ADDENDUM #4

**PROJECT: RENOVATIONS TO THE SCOTLANDVILLE BRANCH LIBRARY - PHASE II
CITY PARISH PROJECT NO. 21-ASC-CP-1449**

ADDENDUM Attachment to City Parish Addendum 4
January 27, 2025

RE: **Renovations to Scotlandville Branch Library – Phase 2**
EBR Project # 21-ASC-CP-1449

PAVING & JOINTING PLAN

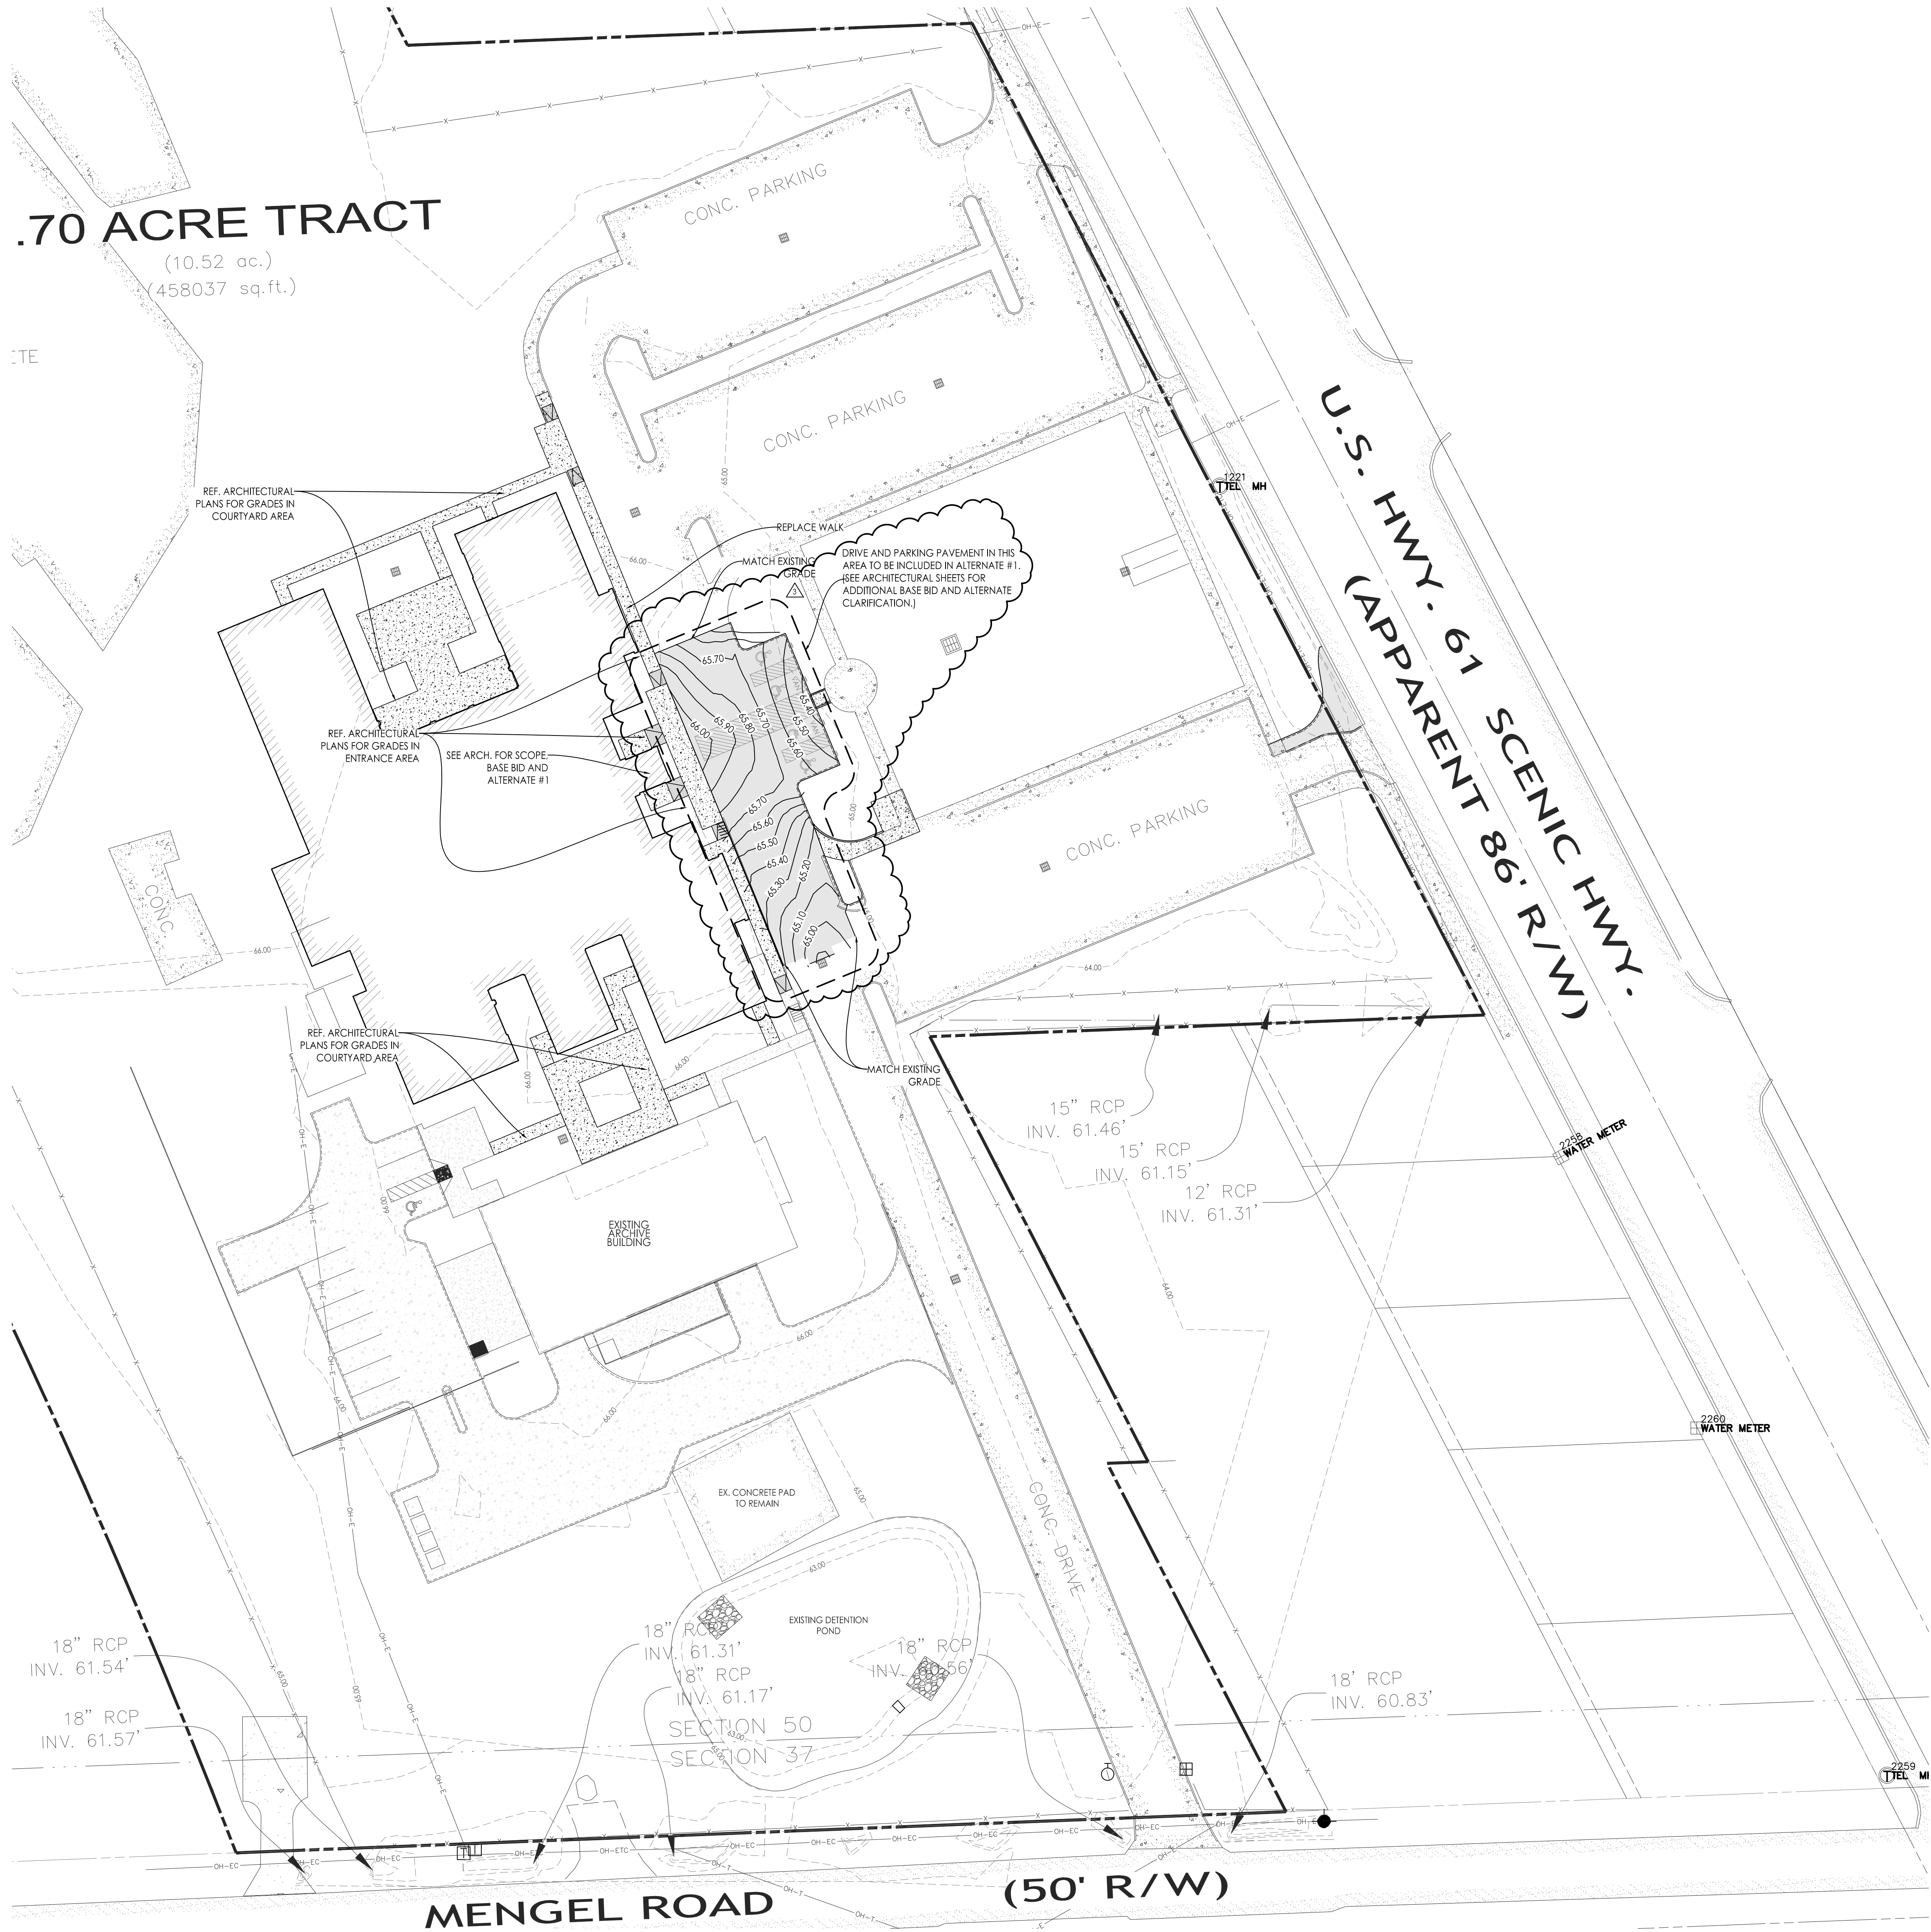
Sheet C2.0 (Paving and Jointing Plan): Updated plan to show revised paving area. Updated to show temporary reconfiguration of driveway connection at U.S. Hwy 61 and to clarify callout of Alternate #1.

BMP SNOUT DEVICE DETAIL - 24F

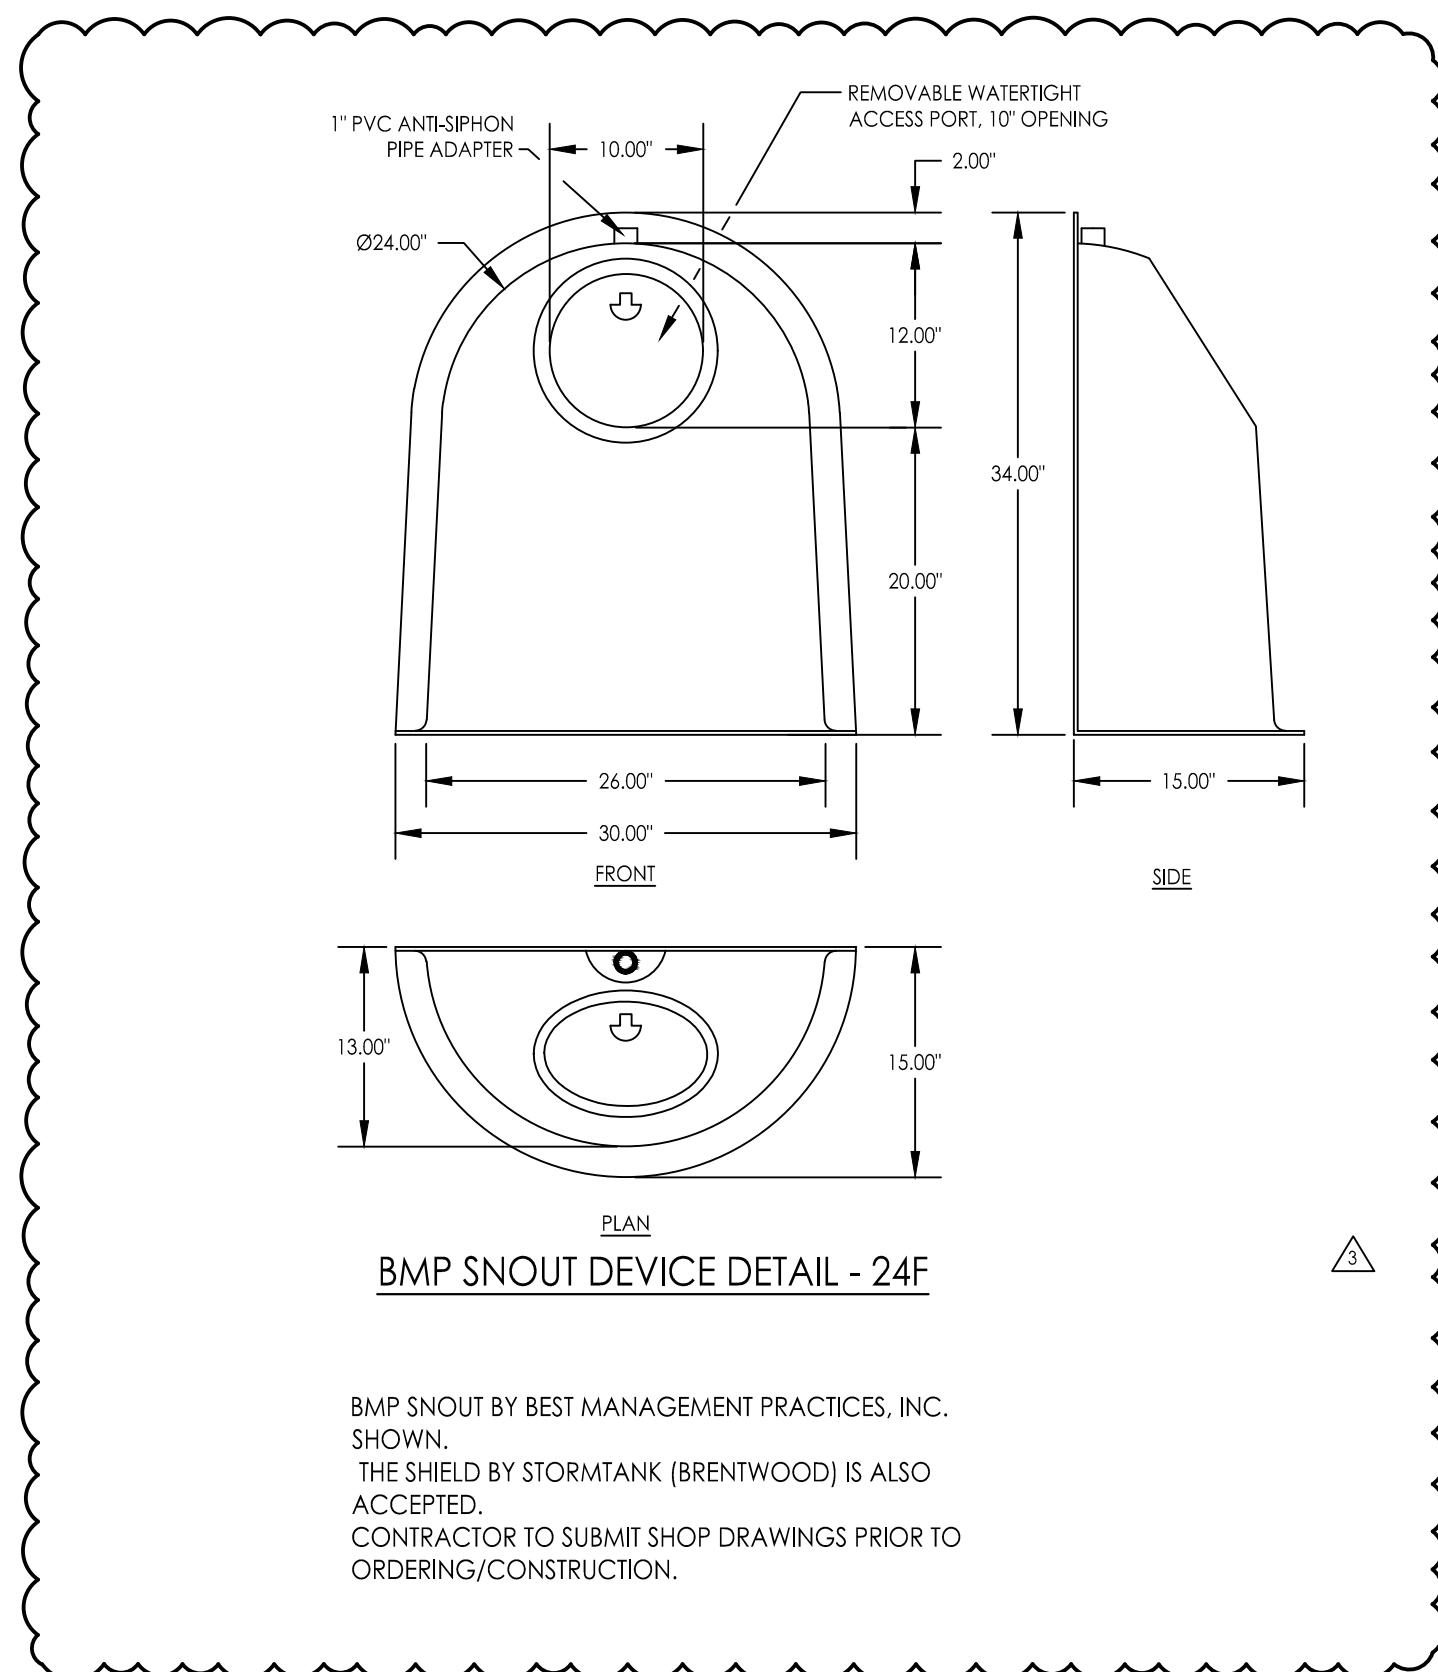
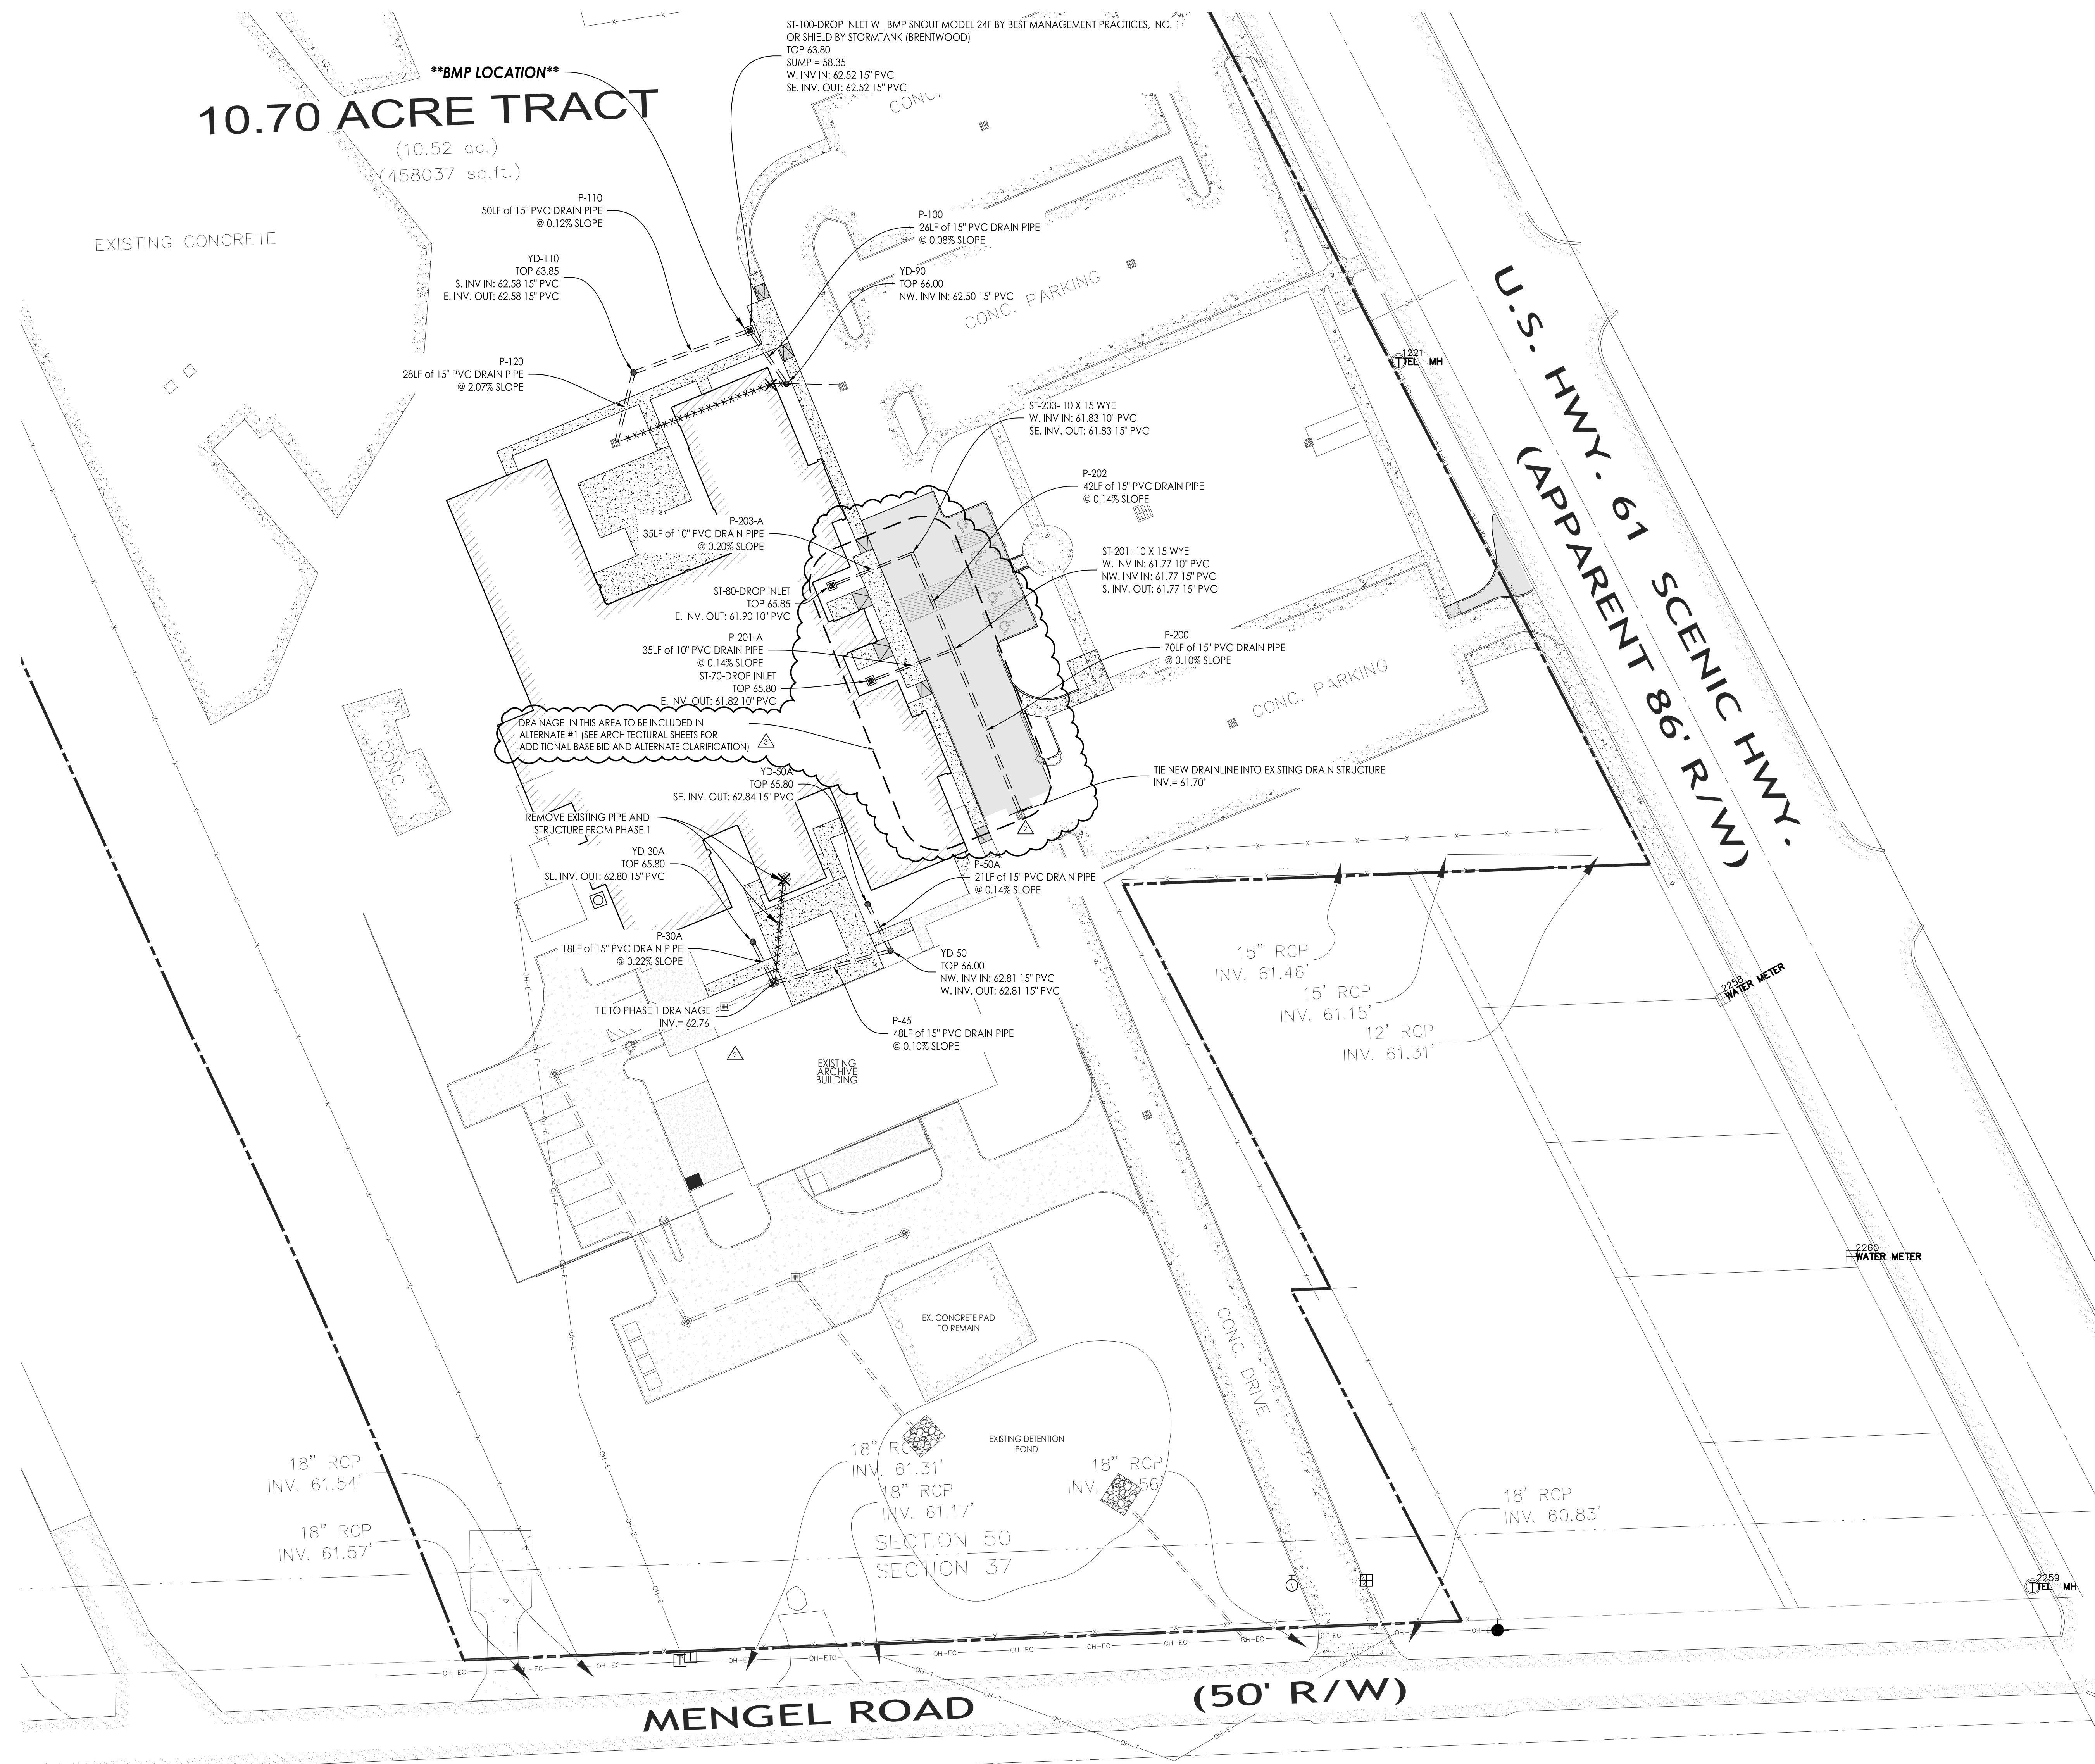
Sheet C4.1 (Stormwater Management Plan): Updated plan to show revised paving area near existing catch basin and show the existing drop inlet being tied into in the south courtyard area between the library and archives building. Clarification call out of Alternate #1 and included a detail of BMP device.
